COUNCIL ASSESSMENT REPORT – MODIFICATION APPLICATION

SYDNEY EASTERN CITY PLANNING PANEL

PANEL REFERENCE & DA NUMBER	PPSSEC-408 MDA-2025/49
PROPOSAL	Modification to DA-2024/10 to change conditions relating to the Plan of Management, fit out of the coffee shop and general design amendments
ADDRESS	13A Church Avenue MASCOT NSW 2020 Lot 1 DP 547700
APPLICANT	The Trustee For Iglu Property Trust No. 216
OWNER	The Trustee For Iglu Property Trust No. 216
MOD LODGEMENT DATE	28 April 2025
ORIGINAL DA DETERMINATION DATE	12 December 2024
APPLICATION TYPE	Modification Application under Section 4.55(2)
REGIONALLY SIGNIFICANT CRITERIA	Clause ##, Schedule 6 of <i>State Environmental Planning Policy (Planning Systems) 2021</i> : [type]
CIV	Original - \$60,064.47 (excluding GST) Modification - \$22,076 (excluding GST)
KEY SEPP/LEP	- State Environmental Planning Policy (Planning Systems) 2021 - State Environmental Planning Policy (Housing) 2021; and - Bayside Local Environmental Plan 2021
TOTAL & UNIQUE SUBMISSIONS ISSUES SUBMISSIONS	Nil

Figure 12: Ground Floor and First Floor – Setback increase

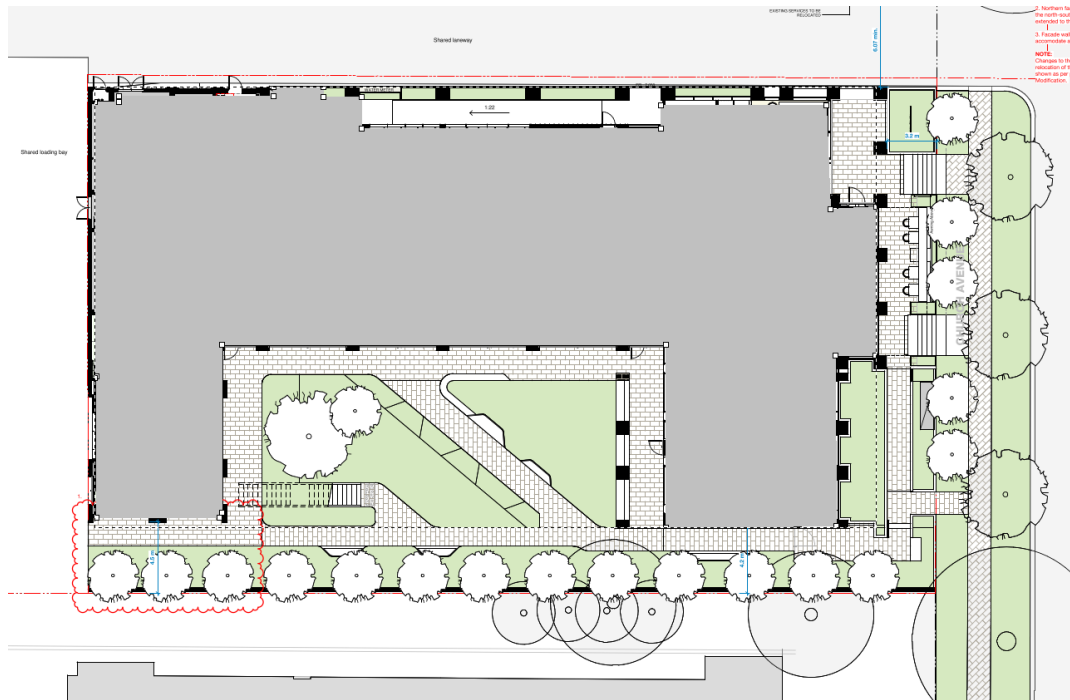
- The setback to the first-floor south-east corner has been increased from 2.9m to 4.5m, with a 1m planter added around the terrace perimeter to satisfy DA condition 22(b).
- The "work zone" has been extended to the approved eastern setback, replacing the approved terrace space with approximately 8sqm of GFA along the north-south corner.
- The façade wall thickness has been increased to accommodate additional insulation.
- Condition 13 is requested to be amended to permit a future café use, allowing detailed fit-out and use approval either through a later DA or a complying development certificate.
- The laundry room has been relocated to the first floor; and
- Modifications to the approved landscape plan to increase the amount of native species from 70% to 73% and reduce the amount of exotic species from 30% to 27%.

first floor has retained the approved 4.2m distance. However, the originally approved 'work zone' communal space has been extended to reach this setback, replacing the previously approved open space terrace area. This change results in an additional approximately 8sqm of gross floor area (GFA).	
--	--	---	--

- *The additional GFA largely comes through a minor adjustment to the level 1 terrace, to convert an area of external communal space into internal communal space. The approved development will continue to exceed the communal indoor and outdoor space requirements in the Housing SEPP. The conversion of part of the terrace to an additional study/co-working area is in response to student feedback about what communal spaces they find most valuable within Iglu's wider portfolio of assets.*

~~(b) The setbacks to the rear first floor terrace/ BBQ Zone are to be amended from 2.9m to 4.5m. A 1m planter box is to be located along the eastern elevation. Therefore, the steps access the ground floor open spaces will be setback at 5.5m from the boundary property~~
